Item Name: Fwd Crosstube - High 407

DART AEROSPACE LTD		Work Order:	149803
Description: Crosstube High Fwd (407)		Part Number:	D407-667-105
Inspection Dwg: D407-667-145 Rev: C		Page 1 of 1

DRAWING NO. D407-667-145	TITLE CROSSTUBE ASS'Y (407 HIGH FWD)	REV. C	DART AEROSPACE LTD ENGINEERING ORDER		D.E.O. NO. D407-667-145-C-1	SHEET NO. SHEET 1 OF 1	SCALE NTS
DRAWN 97	CHECKED ASS	MFG. APPR. 12	APPROVED WD		DE APPR. H		
DATE 11.07.15	DATE 11.07.22	DATE 11.07.22	DATE 11/07/22		DATE 11.07.21

DRAWING NO. D407-667-145	TITLE CROSSTUBE ASS'Y (407 HIGH FWD)	REV. C	DART AEROSPACE LTD ENGINEERING ORDER	D.E.O. NO. D407-667-145-C-2	SHEET NO. SHEET 1 OF 1	SCALE NTS
DRAWN AJS	CHECKED <i>[Signature]</i>	MFG. APPR. <i>[Signature]</i>	APPROVED <i>[Signature]</i>	DE APPR. <i>[Signature]</i>		
DATE 12.08.02	DATE 12.08.02	DATE 12.08.02	DATE 12.08.02	DATE 12.08.02	DATE 12.08.02

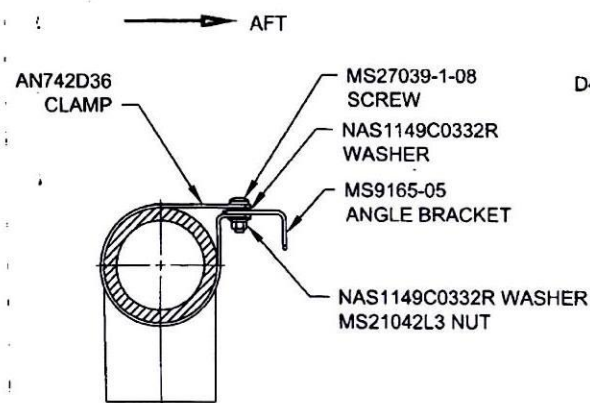
ADD ELECTRICAL GROUNDING STRAP

ITEM	QTY	PART NUMBER	DESCRIPTION
1	X	D407-667-145	CROSSTUBE ASSEMBLY (407 HIGH FWD)
10	2	AN742D36	CLAMP
11	2	MS9165-05	ANGLE BRACKET
12	2	MS21042L3	NUT (OR MS21042-3)
13	2	MS27039-1-08	SCREW
14	4	NAS1149C0332R	WASHER (OR AN960C10L)

- 16) MASK AREA UNDER CLAMP PRIOR TO PAINTING
- 17) SEAL EDGES WHERE AN742D36 CLAMP MEETS WITH THE CROSSTUBE USING SIKAFLEX-241/-291 OR MIL-S-8802 CLASS B2 OR PROSEAL 890 SEALANT
- 18) PERFORM RESISTANCE CHECK TO ENSURE MAX RESISTANCE IS 10 MILLIOHMS
